From: Anna Williams
Sent: 18/07/2025 8:49:13 AM
To: Council Northernbeaches Mailbox; Brittany Harrison
Cc: Gerry Lenihan
Subject: TRIMMED: Submission objecting to DA2025/0167 45A Riviera Avenue Avalon Beach
Attachments: Submission 45A Riviera Avenue Avalon.pdf;

RE: DA2025/0167 Alterations and additions to a dwelling house including a secondary dwelling and garage at 45A Riviera Avenue Avalon Beach

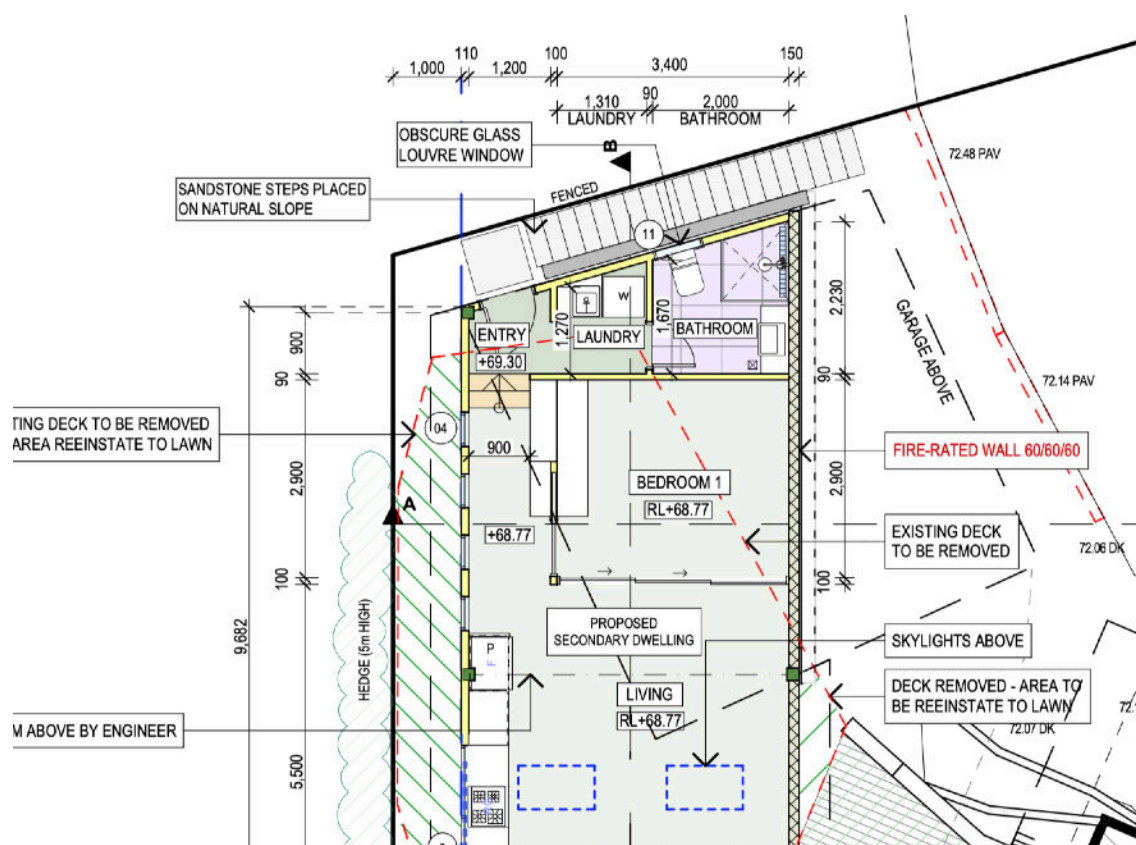
Stormwater plans submitted late in the assessment process have clarified the method of stormwater disposal, being to OSD and then to a level spreader located less than 3m from the shared boundary with No. 10 Capua Place. We note that the very steep land in the location of the level spreader falls in the direction of the boundary with No. 10 Capua Place.

Figure 2: A photo of the existing deck taken from the geotechnical report prepared by Ascent Geo. The pink circle indicates the area of likely substantial excavation to construct the bathroom for the secondary dwelling

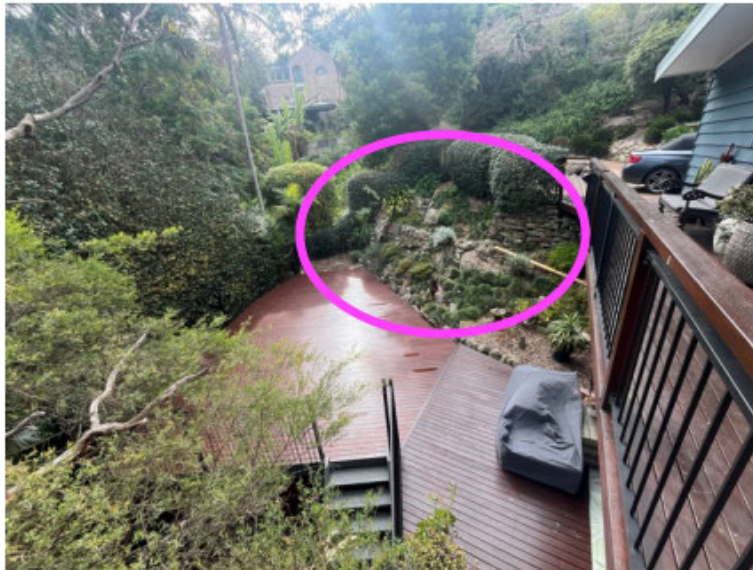
The architectural plans, read together with survey information suggest that excavation of up to 3m may be likely at the north eastern corner of the proposed bathroom for the secondary dwelling. Drawing No. DA.03 shows the proposed bathroom and bedroom extending beyond the line of the existing deck to be demolished. An excerpt of the plan is provided below:

We are concerned that the likely retaining walls required for the excavated northern end of the secondary dwelling are not adequately addressed in the geotechnical assessment and request that this aspect of the development be reviewed and recommendations provided.

Figure 4: Excerpt from survey showing correct levels adjoining the boundary of RL 66.37 **Source:** CMS Surveyors
Annotation (pink): Blackwattle Planning

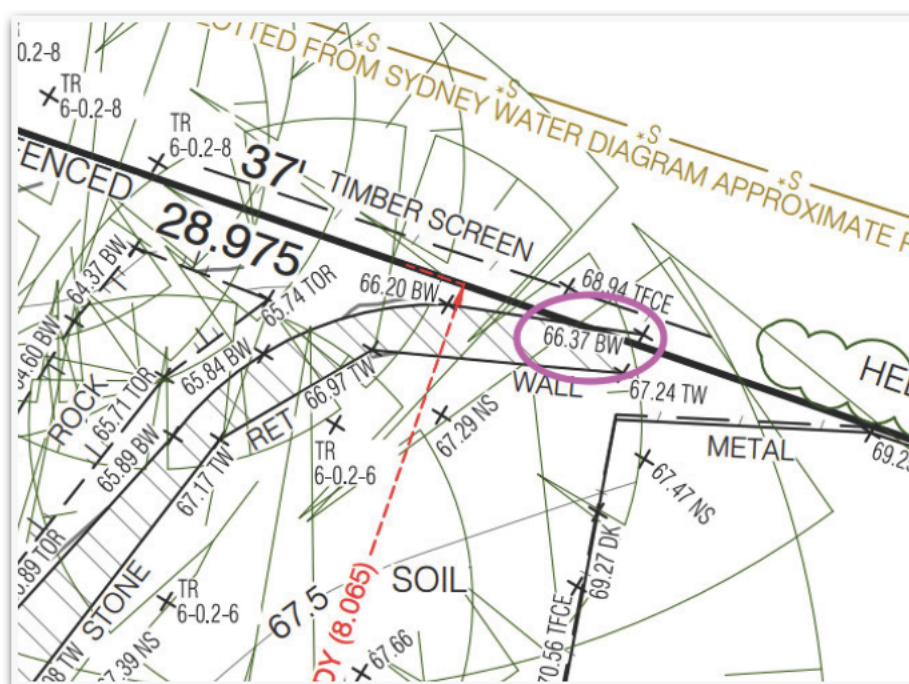
In arriving at this conclusion we have utilised the levels on the applicants survey, which show the bottom of a stone retaining wall crossing the boundary at RL66.37. This level is the closest level to the boundary and aligns with the southern elevation of the secondary dwelling, perpendicular to the shared western boundary. See excerpt from survey below, with pink circle identifying boundary level:

Figure 5: The applicants building envelope shown as measured well above the ground levels at the boundary. From RL 66.37, the envelope intersects the building 1m below the pitching point **Source:** JJ Drafting
Annotations (red and pink): Blackwattle Planning

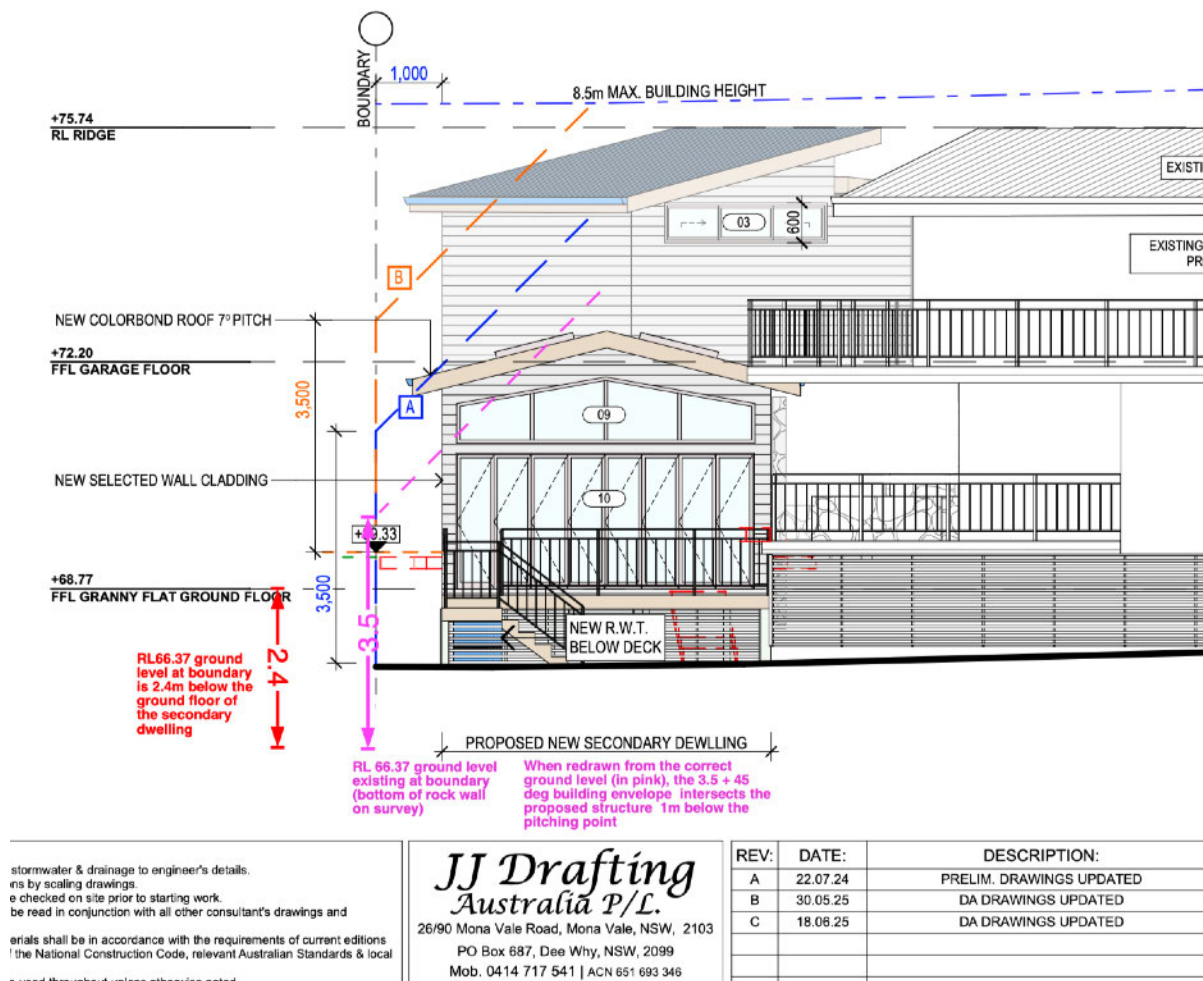
Based on the above, Council should not rely upon the accuracy of the building envelope drawn on the submitted plans and we welcome Council's close examination of this issue. Upon a site inspection and a proper understanding of the location of the shared boundary, it is clear that the proposed secondary dwelling will tower above the private open space of No 10 Capua Place and result in a scale that is overbearing, enclosing of this space, and highly visually intrusive.
